RE: 6030 Iliff Rd. NW

Grading and Drainage Plan Engineer's Stamp Date: 08/26/19

Hydrology File: J11D024

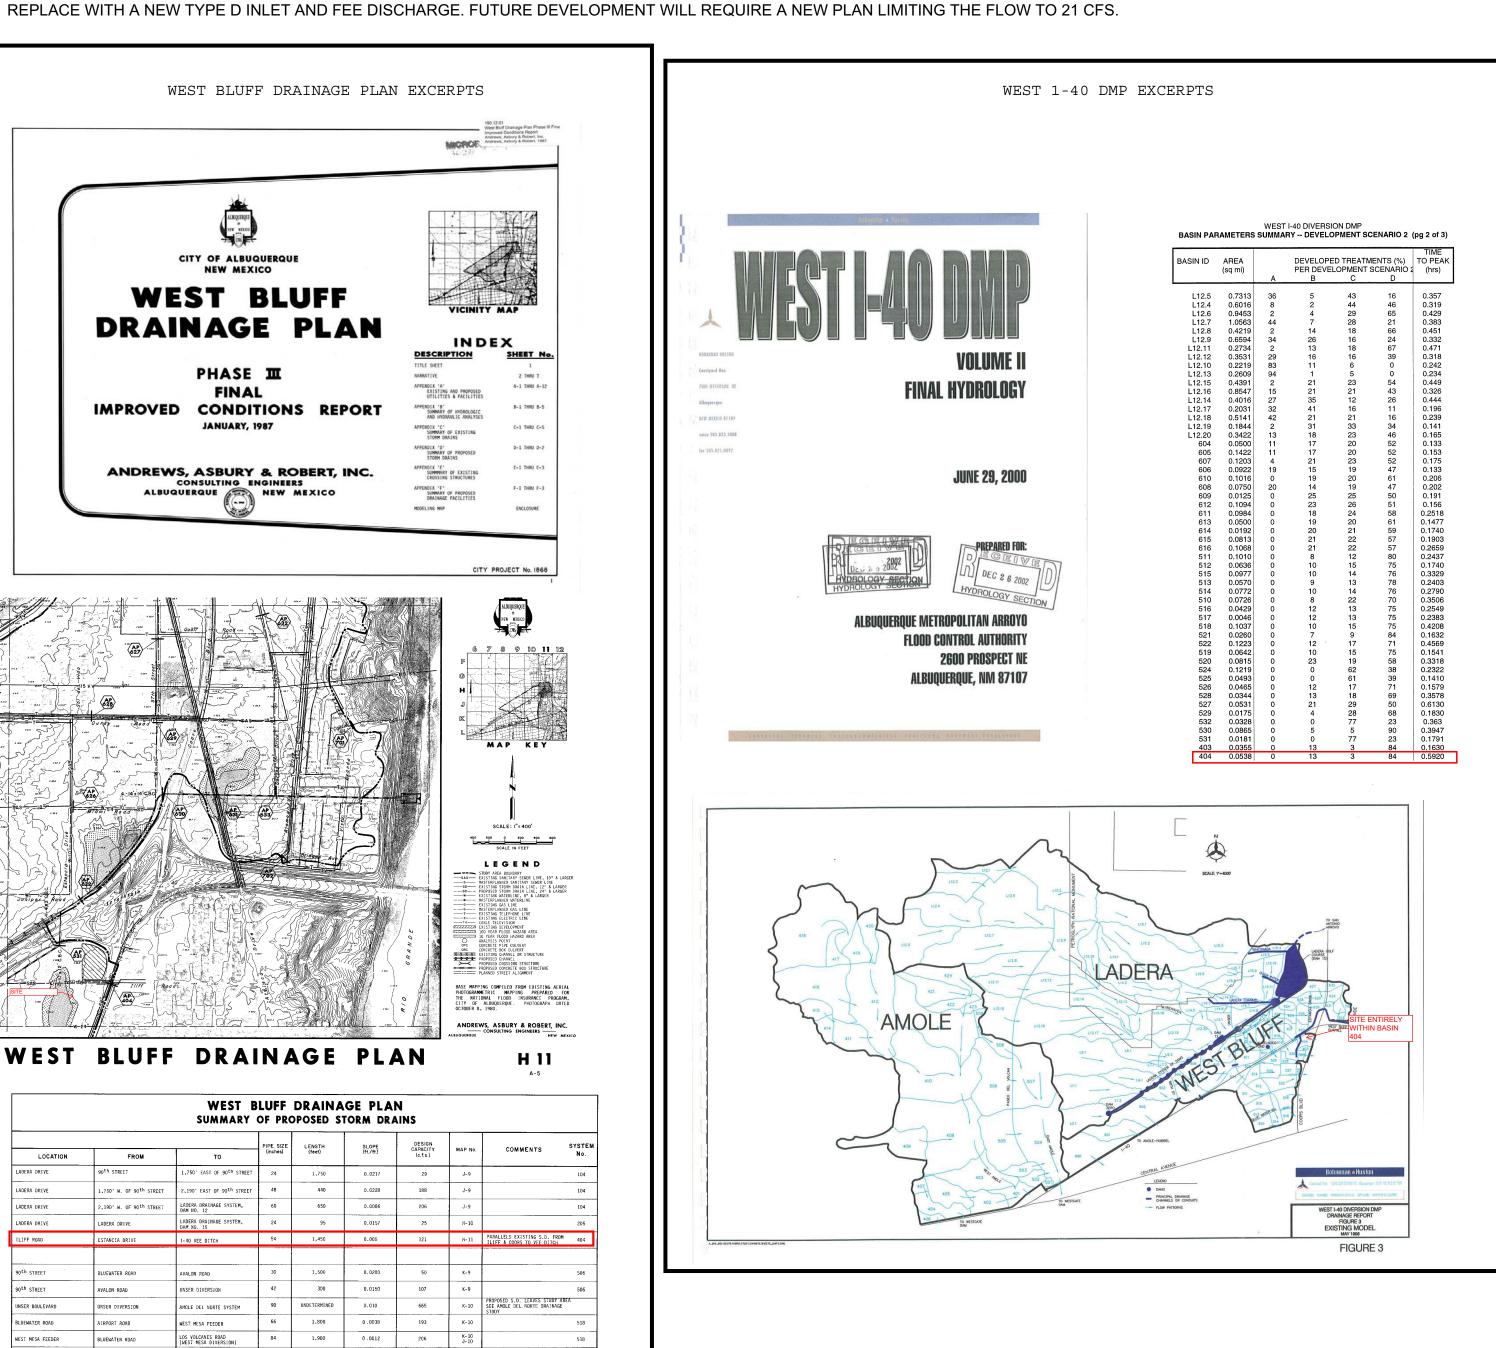
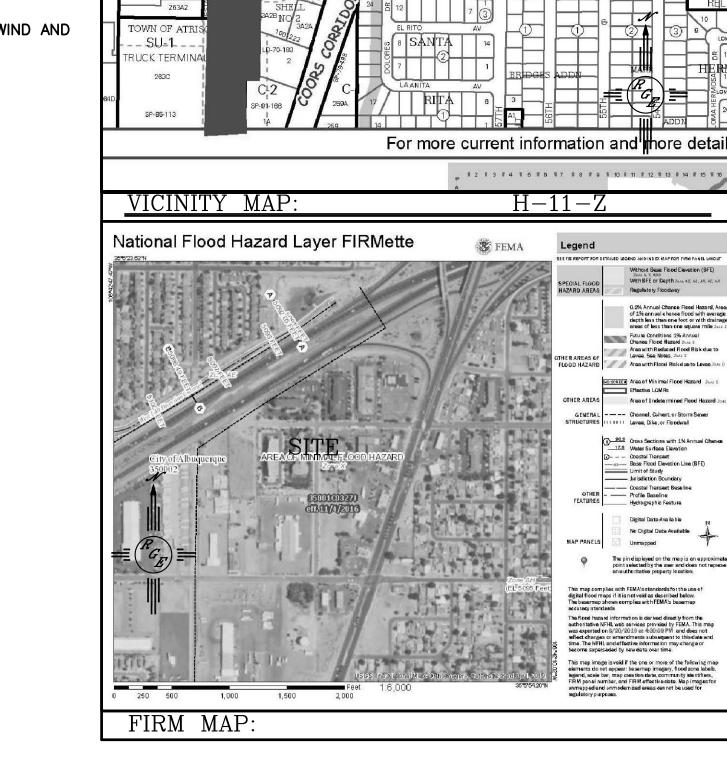
Please note, that the Plat will need a cross lot easement on Tract 261-A-2 for the benefit of Tract

261-A-1 (the existing hotel). Once Tract 261-A-2 is to be developed, an approved Grading and Drainage Plan will be required from Hydrology. Also Tract 261-A-2 will have to be designed

per this approved Grading and Drainage Plan with the limited discharge of 21 CFS for both
